October 2021 | Danfoss Climate Solutions for cooling

TECH

INSIDER

New Oil Level Sensor Electrical Part Release

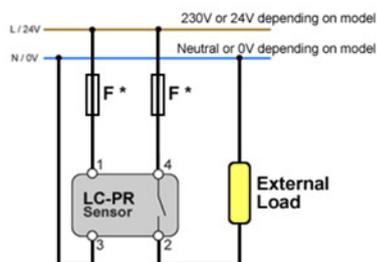
To provide a better user experience, Danfoss will release a new oil level sensor electrical part - LC-PR - which can output relay signal. This new oil level sensor electrical part is available for A2L refrigerants.

Compared with the current oil level sensor electrical part (LC-XN), this new sensor (LC-PR) outputs a relay signal instead of a solid-state signal. Due to this update, please refer to the below diagram.

Semi-Hermetic Filter Drier - One Core Shell UL 207 Approved for A2L Refrigerants

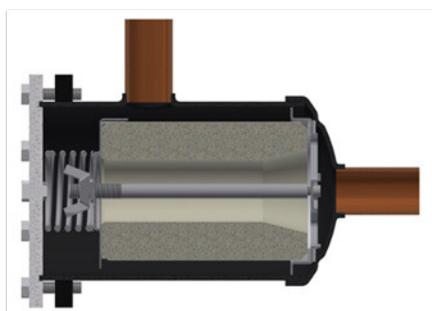
Danfoss is launching a new range for semi-hermetic filter driers DCR E 48 with one core. The shell body made from steel, coupled with copper connectors are designed specifically for flammable refrigerants classified under A2L (i.e., R32, R444A, R444B, R445A, R446A, R447A, R451A, R452B, R454B, R455A, R1234yf, etc.). This product is now approved under UL 207. Visit the [datasheet](#) for more information.

DCR E 48 shell can withstand a **Maximum Working Pressure of 50 Bar (725 psi)** and a working temperature range of **-40 °C to 70 °C (-40 °F to 160 °F)**. The DCR E shells should be used for flammable refrigerants only like: R32, R444A, R444B, R445A, R446A, R447A, R451A, R452B, R454B, R455A, R1234yf, it can be used in the liquid line and it meets with UL 207 requirements.

DCR E Flammable
(Updated)

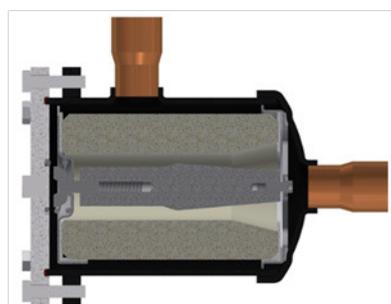
- Inner free vol. 0,88 liters, and connector with inner diameter less than 25 mm
- Group 1 (A2L) and 2 refrigerants
- PED category A4P3 due is less than 1 L, CE mark not required
- Approved according UL 206
- New copper connectors 1 3/8 and 1 5/8

Salient features:

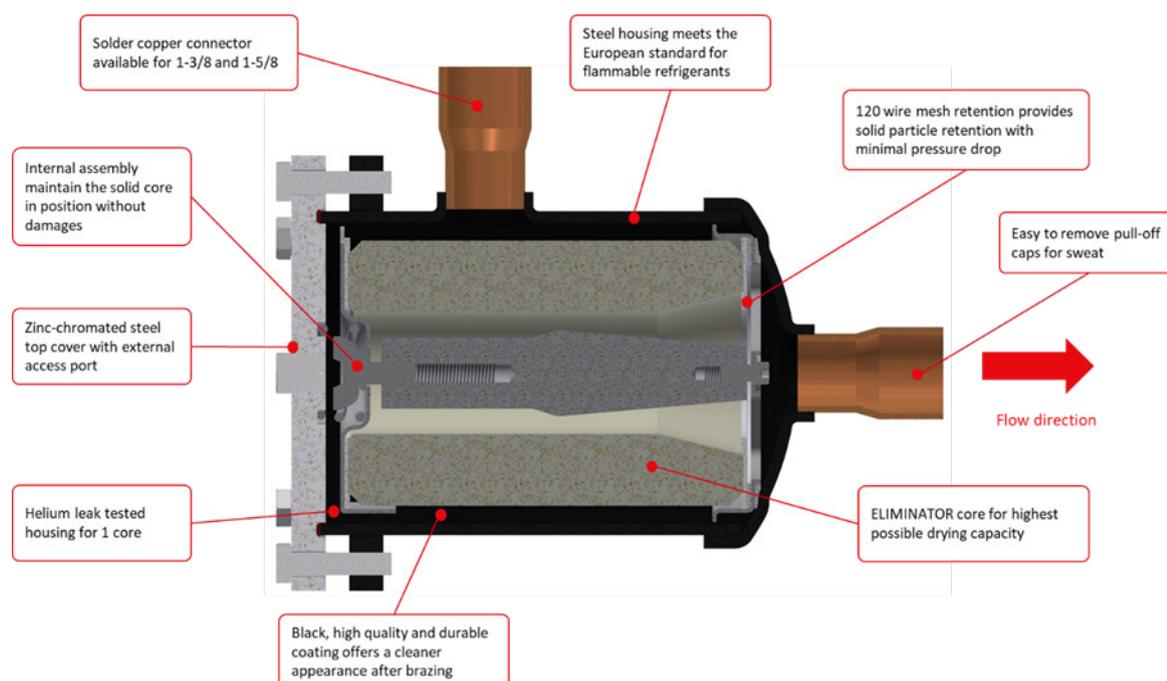
- Increased steel thickness to meet with the pressure requirements for flammable refrigerants.
- Increased cover thickness from 12 to 15 mm **(New update from 2021)**.
- Change bolts to M10 **(New update from 2021)**.
- Torque changed to 50 Nm **(New update from 2021)**.
- The same approved material specification as in existing DCR range.
- A4P3 PED category - no need of CE mark.
- UL 207 approvals **(New update from 2021)**.
- RoHS Directive 2011/65/EU including amendment 2015/863/EU applying the exception 6(a).
- Available in pure copper connectors for quick brazing.
- The same benefits as existing DCR semi-hermetic filter drier product line: internal cleanliness, solid core, particles retention larger than 120-micron, helium leak test, plastic caps, and proven reliability.
- New copper connector sizes of 1-3/8 and 1-5/8 **(New update from 2021)**.

IPS 8 stand still period before start-up

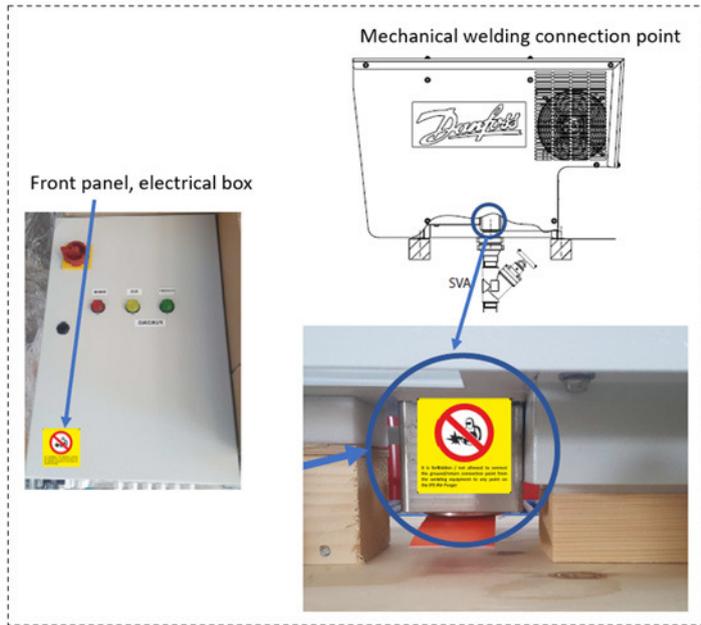
Quite often the IPS 8 will be lifted to a roof or at a higher level from the ground floor. During the lifting, typical by a crane, the IPS 8 may tilt back and forth. Once the IPS is at its final location, there is a risk that the oil and liquid have been moved around inside the IPS 8.

For that reason, it is needed to secure that the IPS 8 stand-still for **minimum 6 hours** before switching on the power supply.

To notify the installer we have placed a yellow sticker inside the electrical box, near the MCB (Main Circuit Breaker)
